HAWAII HEALTH SYSTEMS CORPORATION  
KAUAI REGION

ADDENDUM #1

TO: Potential Offerors  
FROM: Maia Guirao, Contract Manager  
RE: Solicitation Addendum #1 to RFP #24-01/Renovation for CAH Beds

**A**  
 A1.0 LOWER LEVEL PLAN  
 SCALE: 1/8" = 1'-0"

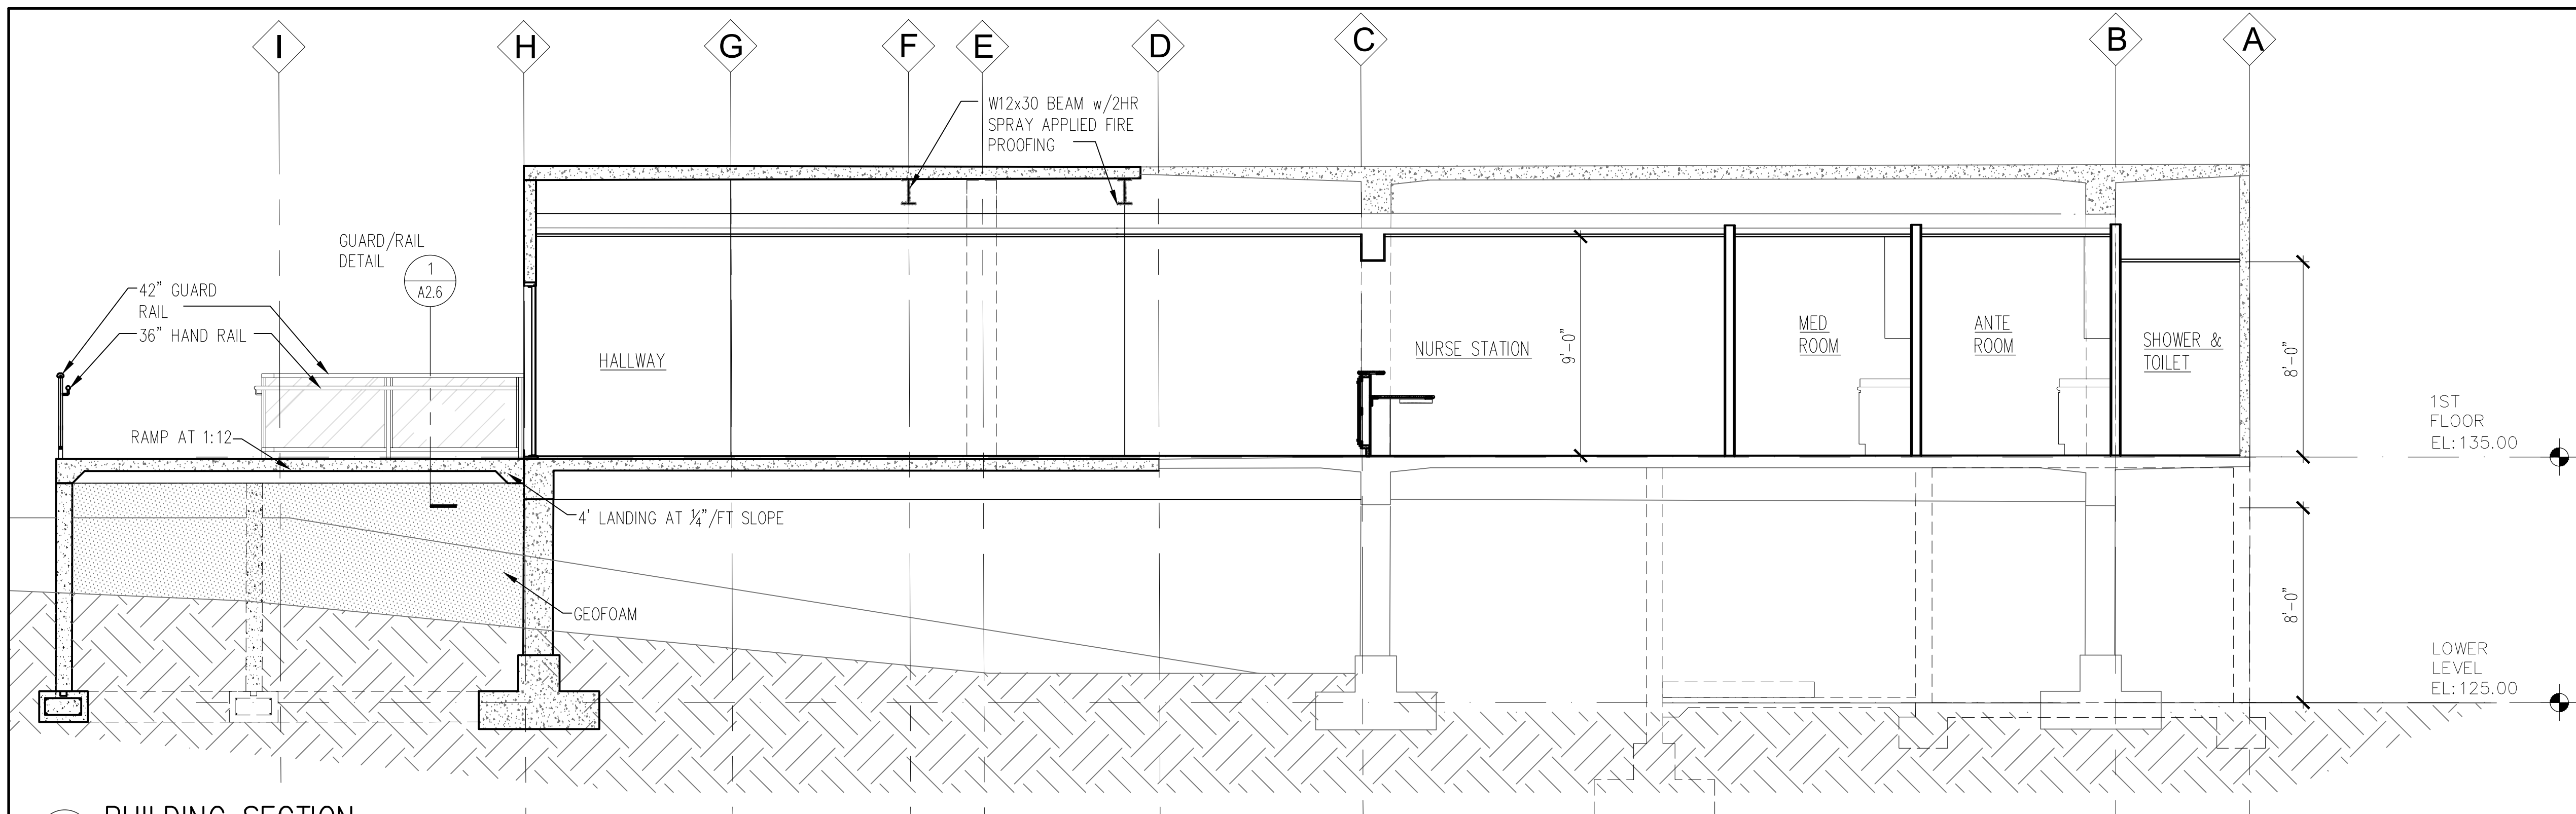
1. Drawings **A1.0 – Lower Level Plan R1** and **A2.6 – Building Sections R1** were provided for your reference.

**1 GUARD/RAIL DETAIL**  
 SCALE: 1/4" = 1'-0"

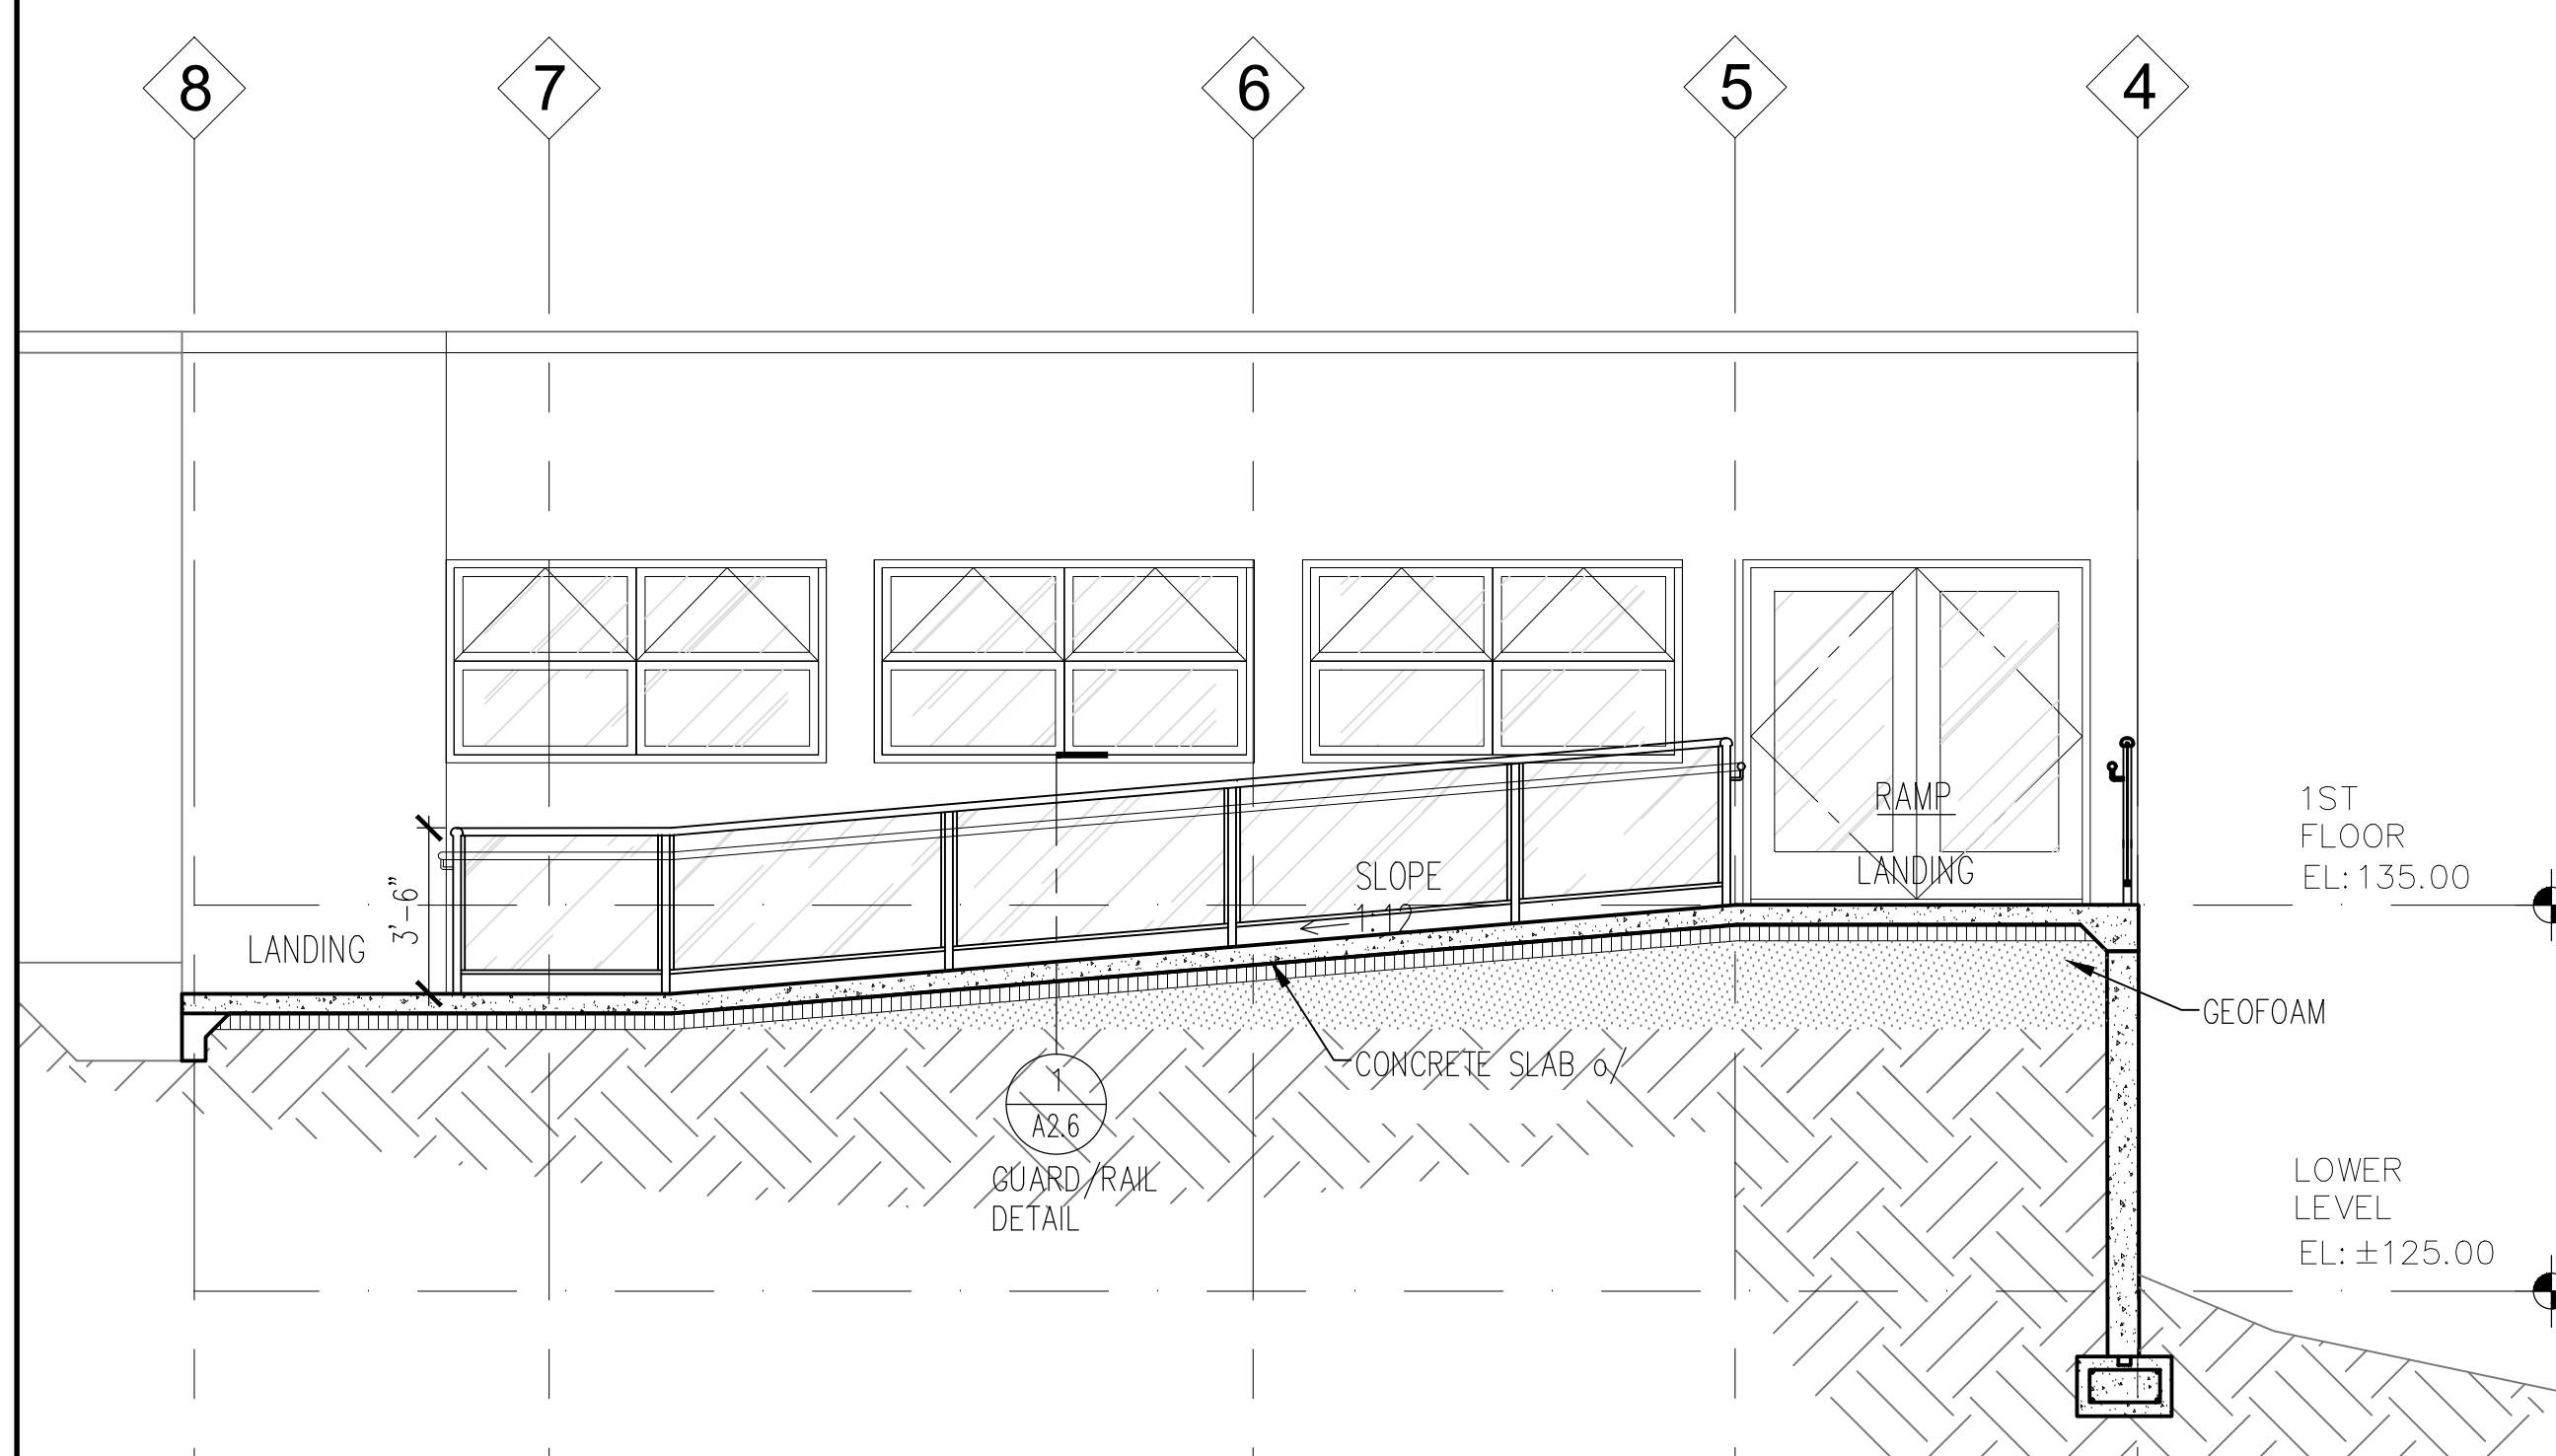
25. Q: Reference Drawing Sheet A2.6 detail 1/A2.6. Please provide thickness of glass for the railing.

26. Q: Reference Detail 1/A2.6 – Please provide required finish for the Pre-Manufactured Aluminum Guardrail.

A: Glazing to be 3/8” clear tempered glass

A: Provide clear aluminum finish.
